August 27, 2020 – Rev. 1

**Subject: Traffic Consulting Peer Review
Proposed Dracut Senior Housing Development
Dracut, Massachusetts**

This peer review focuses on traffic-related information contained in the June 2020 Chapter 40B Comprehensive Permit Application and the August 13, 2020 site civil plans prepared by BWA Architecture and Places Associates, Inc. on behalf of Common Ground Development Corporation.

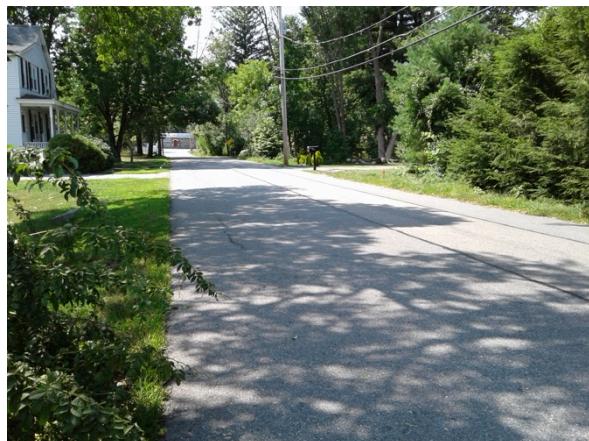
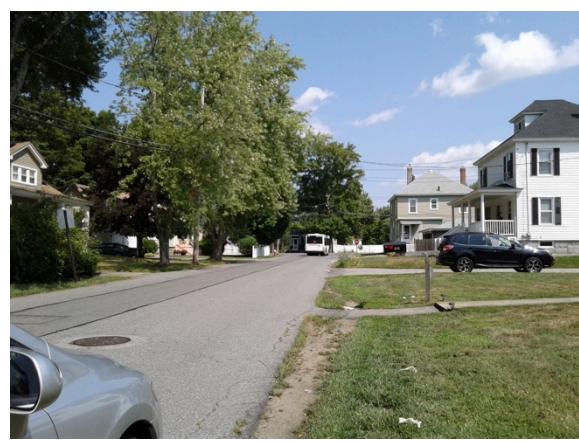
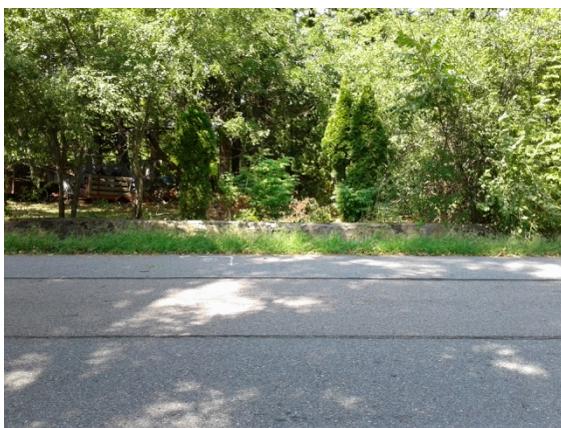
Traffic and pedestrian/bike circulation conditions were observed on Greenmont Avenue and its intersections with Bridge Street (Route 38), Vermont Avenue and Pleasant Street (Route 113). Sight lines were also reviewed at the proposed cul-de-sac driveway intersection with Greenmont Avenue and are shown on the page that follows. The Greenmont at Vermont Avenues intersection has three-way, or all-way stop control and an LRTA Route 10 bus stop on its southwest corner. The Pleasant Street (Route 113) has bus stops on its Greenmont Avenue corners. A Route 10 bus was observed travelling down Greenmont Avenue in an easterly direction during the site visit.

The site visit indicates that Greenmont Avenue has an open drainage system with no curbing or catch basins and a paved width varying from 22-24 feet. Directly in front of the site's future driveway, its paved width is of approximately 24 feet. Its background traffic volumes are estimated to be relatively low, ranging from 500-1,500 vehicles per day during 'non-pandemic' conditions. Its pavement is in good condition with some minor cracking. It has no centerline or shoulder pavement markings and no sidewalks. Greenmont Avenue has one crosswalk at its Elementary School just south of its intersection with Spring Park Avenue. On-street parking is not permitted on Greenmont Avenue. Assuming the Town routinely trims back vegetation in the public layout, the field review found that the future cul-de-sac driveway would have adequate sight lines to provide intersection sight distances of approximately 500 feet in both directions.

We recommend that the Town of Dracut keep vegetation in the roadway layout along the site frontage at 144 Greenmont Avenue trimmed to less than 3.5' in height. This should be done near the site driveway to ensure adequate sight lines for vehicles exiting and entering the driveway. Should a bus stop waiting shelter be provided, we recommend ensuring adequate sight lines through it looking to the left from the site driveway.

*Excerpt: MassDOT Crash Portal
Greenmont Avenue reported crashes 8/2015 to 8/2020*

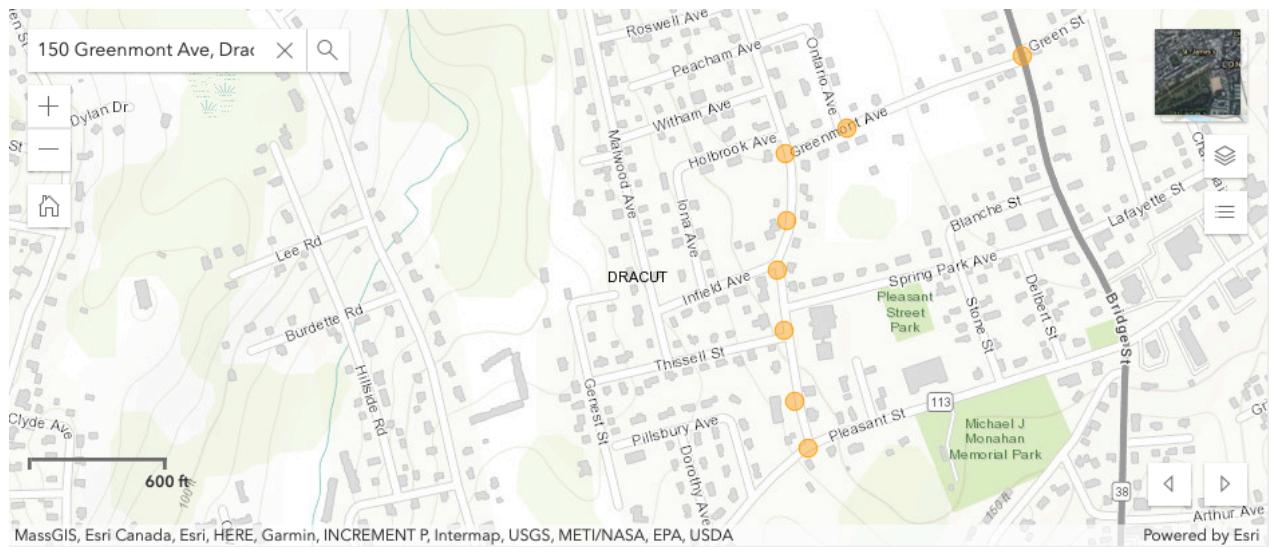
The Peer Reviewer checked MassDOT's crash portal to review crash rates on Greenmont Avenue. During the last five years, a total of 8 crashes were reported along Greenmont Avenue. Of these, seven involved property damage only, and one may have involved an injury. No fatal crashes were reported. No Greenmont Avenue intersection experienced more than one reported crash during a five-year period. Refer to the next page for an excerpt from MassDOT's IMPACT crash portal for Greenmont Avenue.

We therefore conclude that the *Greenmont Avenue is not a high-hazard/high crash rate roadway* and should operate safely for the foreseeable future.
